# DART SERVICE INSTRUCTION

TO AMEND INSTALLATION INSTRUCTIONS IIN-D412-702 REV. D & E

A	NEW ISSUE	LE	08.03.05
REV.	DESCRIPTION	BY	DATE
DESIGN		<b>DART AEROSPACE LTD</b>	
DRAWN		HAWKESBURY, ONTARIO, CANADA	
CHECKED		DRAWING NO.	REV. A
MFG. APPR.	N/A	DSI 9408	SHEET 1 OF 1
APPROVED		TITLE	SCALE
DE APPR.		HOOK AND LOOP STRIP	NTS
DATE	08.03.05	COPYRIGHT © 2008 BY DART AEROSPACE LTD	
THIS DOCUMENT IS PRIVATE AND CONFIDENTIAL AND IS SUPPLIED ON THE EXPRESS CONDITION THAT IT IS NOT TO BE USED FOR ANY PURPOSE OR COPIED OR COMMUNICATED TO ANY OTHER PERSON WITHOUT WRITTEN PERMISSION FROM DART AEROSPACE LTD.

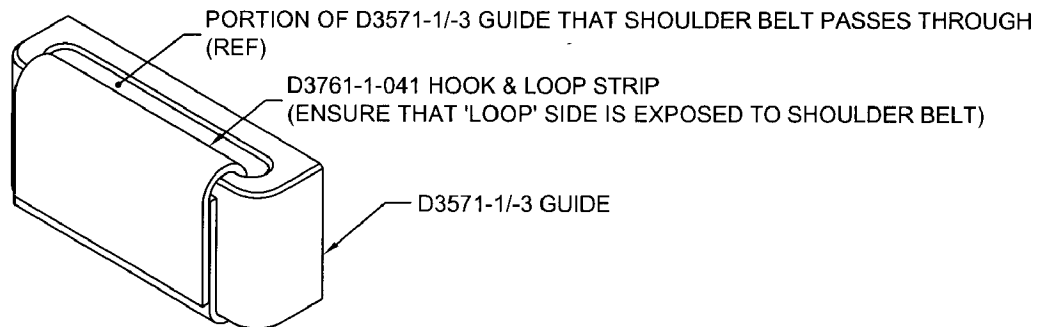
The DSI9408 kits provide D3761-1-041 hook and loop strips that help prevent passengers from inadvertently pulling the shoulder belts out of the D3571-1/-3 guides. Installation of the D3761-1-041 hook and loops strips is optional.

The D3761-1-041 hook and loop strip is installed by wrapping the strip tightly around the front face of the D3571-1/-3 guide so that the "loop" side of the strip is exposed to the shoulder belt as shown in the figure below. The kits are as follows:
